Number: 19004

PRODUCT CHANGE NOTIFICATION

MALLORY	Mallory Sonalert	Part #	PB-1420PL-03BMQ
	Products Inc.		
Sales	Outline Drawing	Revision	A

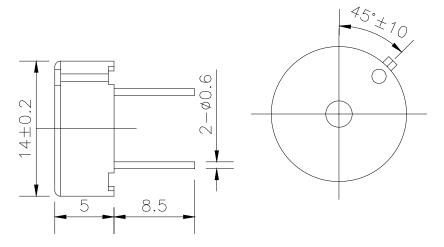
Reactions to this notification are to	be addressed to Mallory Sonalert Sal	es Representative or Quality Control
	PRODUCT / MODEL CHAN	GE .
PB Series Change PB-1420PL-03AQ (O	BSOLETING) to PB-1420PL-03BMQ	
There is a frequency difference in the nev	CHANGE DESCRIPTION v part. From 2000 hertz to 2048 hertz.	
Old part is no longer available	REASON FOR CHANGE	
Frequency increased slightly from old pa	CHANGE OF FIT / FORM / FUNC rt	CTION?
Use old parts as is.	DISPOSITION OF OLD PROD	UCT
EST DATE CODE: 1939-3 / Immediately	IMATED CODE DATE OF EFFECT	ED PRODUCT
NONE	COMMENTS:	
Daw Clark		
Approved By: Dan Clark	TITLE: Quality Manager	DATE: 9/23/2019
By:	TITLE:	DATE:

Oscillation Frequency (Hz)	2048	
Operating Voltage (Vp-p)	1 ~ 4	
Rated Voltage (Vp-p)	3	
Current Consumption Max. (mA)	35 at Rated Voltage	
Sound Pressure Level (dB/min)	85 at 10cm at Rated Voltage	
Coil Resistance (Ω)	40 ± 6	
Operating Temperature (°C)	- 30 ∼ +70	
Storage Temperature (°C)	-4 0 ∼ +80	
Lead Pin	Tin Plated Brass	
Housing	NORYL	
Weight (Grams)	2.0	
Condition by wave soldering (°C)	260 ± 5 / within 5 sec	
Condition by hand soldering (°C)	350 ± 10 / within 5 sec
